The Commission has issued the enclosed Amendment No. 81 to Facility Operating License No. DPR-28 for the Vermont Yankee Nuclear Power Station. The amendment consists of changes to the Technical Specifications in response to your application dated May 26, 1983.

VERMONT YANKEE NUCLEAR POWER CORPORATION

AMENDMENT TO FACILITY OPERATING LICENSE

Amendment No. 81  
License No. DPR-28

Figure 3.6.1  
 Reactor Vessel Pressure  
 Temperature Limitations  
 for Operation Through 1.330E9MWh<sub>(t)</sub>  
 RTNDT @ 1/4T = +92°F @ 3/4T = 75°F

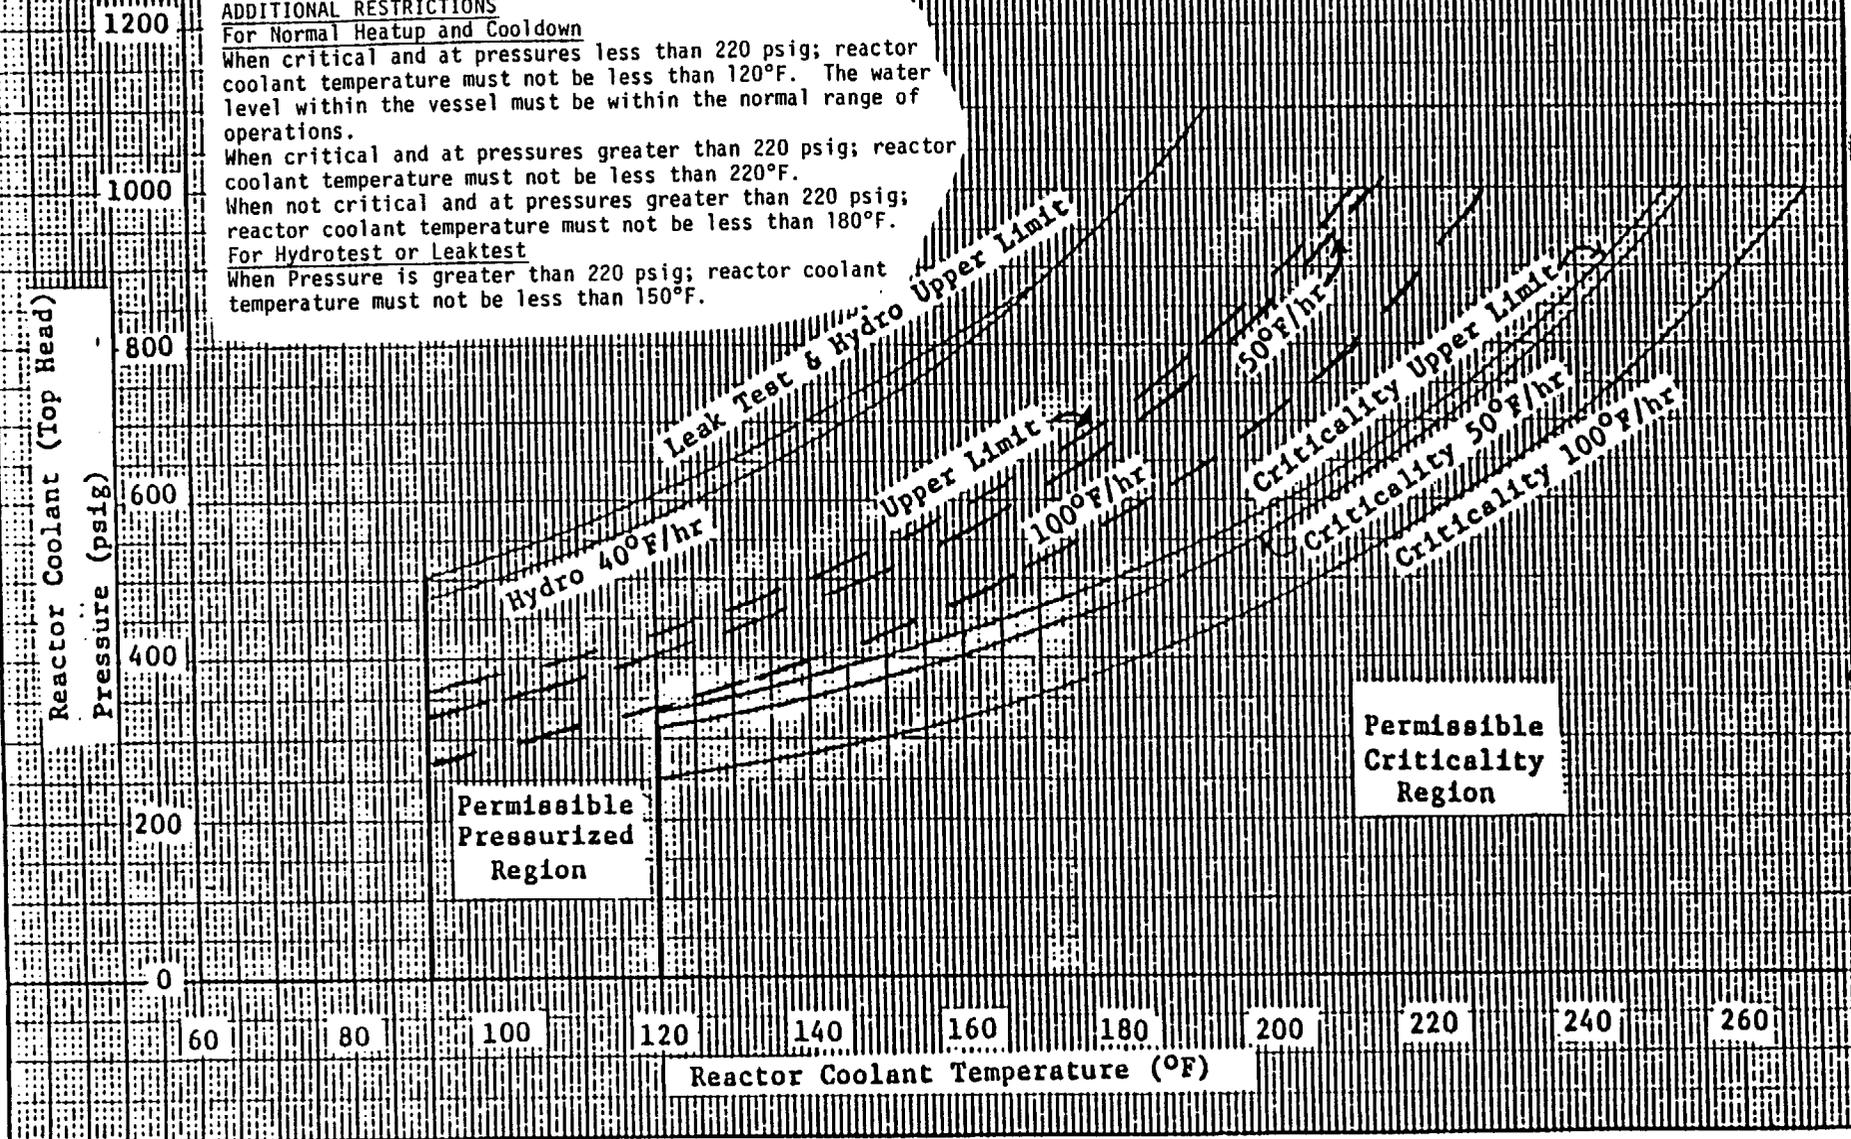
The amendment revises the Technical Specifications to accommodate shifts in transition temperature for the reactor pressure vessel materials that were induced by radiation damage. These shifts are accounted for by revision of the plant pressure-temperature limits for heating up and cooling down the reactor vessel. Periodic review and adjustment, if necessary, of the curves to account for the effects of irradiation are required by 10 CFR 50, Appendices G & H.

We have required certain additional restrictions which we have listed as "Additional Restrictions" on Figure 3.6.1 of the proposed Technical Specifications. These restrictions must be observed during normal heatup/cooldown, core critical operations, and during hydrostatic testing in order to meet the closure flange pressure temperature safety margins of the revised regulation (effective after July 26, 1983). The licensee, in a telecon on February 22, 1984, agreed with the staff to these additional restrictions in order to make the Technical Specifications agree with the revised regulation. The changes do not affect the discussion or conclusion of the initial notice of this action in the Federal Register in any way. The staff finds the changes to be acceptable because they are required by the revised regulation, and the explicit inclusion of these requirements in the Technical Specifications will be consistent with the Standard Technical Specification practice of fully expressing the reactor vessel pressure temperature limitations.

When critical and at pressures less than 220 psig; reactor coolant temperature must not be less than 120°F. The water level within the vessel must be within the normal range of operations.

When critical and at pressures greater than 220 psig; reactor coolant temperature must not be less than 220°F.

When not critical and at pressures greater than 220 psig; reactor coolant temperature must not be less than 180°F.

When Pressure is greater than 220 psig; reactor coolant temperature must not be less than 150°F.
